## Committee on Tidal Hydraulics

### Minutes of the 102nd Meeting

### 31 August-2 September 1993

**Plan View of ESTEX Flume Design  
All Dimensions In Feet**

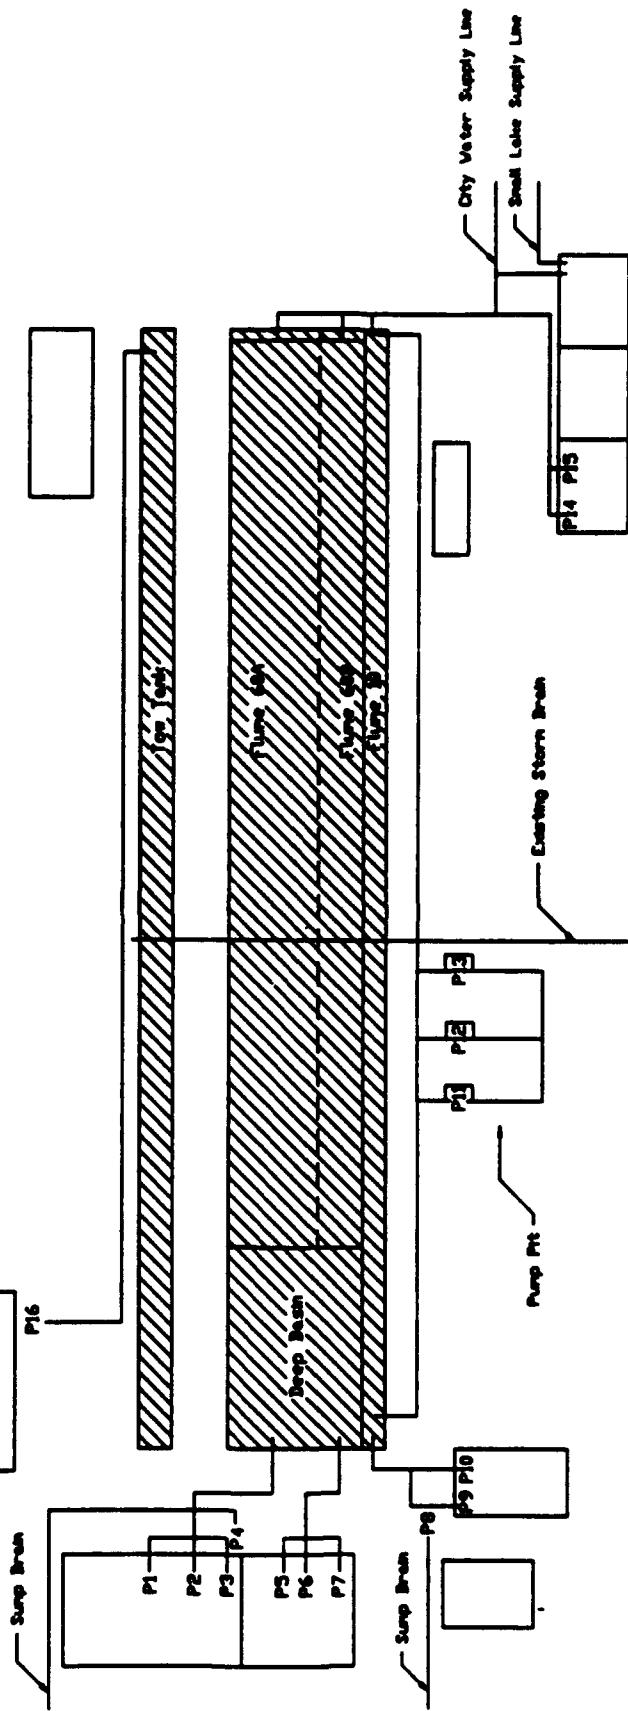
- b. Mr. Herrmann: The flume needs a tilting section. As an alternative, perhaps add higher walls at upstream end to generate larger slopes and higher Froude numbers. It may be wise to place pipes for a 300-cfs capacity, even if the pumps of that size are not installed at first.

- c. Dr. Krone: This flume will provide a facility for many fundamental studies that cannot be performed at present. For example, defining friction factors of muds requires a very long flume to measure the small differences in water level. The same is true for defining friction factors over sands for very shallow depths. ESTEX can be used to show the effect of water depth on Manning's roughness coefficient and to study vertical mixing in variable density flows. It is important to prepare a research program to begin the flume's work. (Dr. Krone also provided a follow-up letter with recommendations (enclosure 7).)

2. The dimensions that you described at the CTH meeting appeared to provide flexibility. The most important aspect of the dimensions is the channel width to water depth ratio. Except for strongly stable density profiles, the width to depth ratio should be large to reduce the effects of sidewalls on flows. A major area for future research is the effects of secondary currents on transport and mixing -- in both unidirectional and oscillatory flows. Secondary currents in flumes are strongly affected by the presence of sidewalls, and some very un-natural erosion and deposition patterns have resulted from low width to depth ratios. Because of the simple geometry of a flume, the width to depth ratios of estuaries and rivers need not be reproduced.

The capacity of the pump(s) will depend on the applications planned. For cohesive sediment studies, it would be nice to be able to resuspend deposited sediment by high flows that create bed stresses of 10 dynes/sq cm or more. If such a capacity can not be provided, it will be necessary to suspend the material mechanically by a rototiller-like device (or the Chinese "River Dragon").

5. Sediment studies in large flumes require access by trucks, skip loaders, and small tractors. Either a gate in the side of each channel or a removable ramp should be planned. A gate is much more convenient, but requires effective seals.
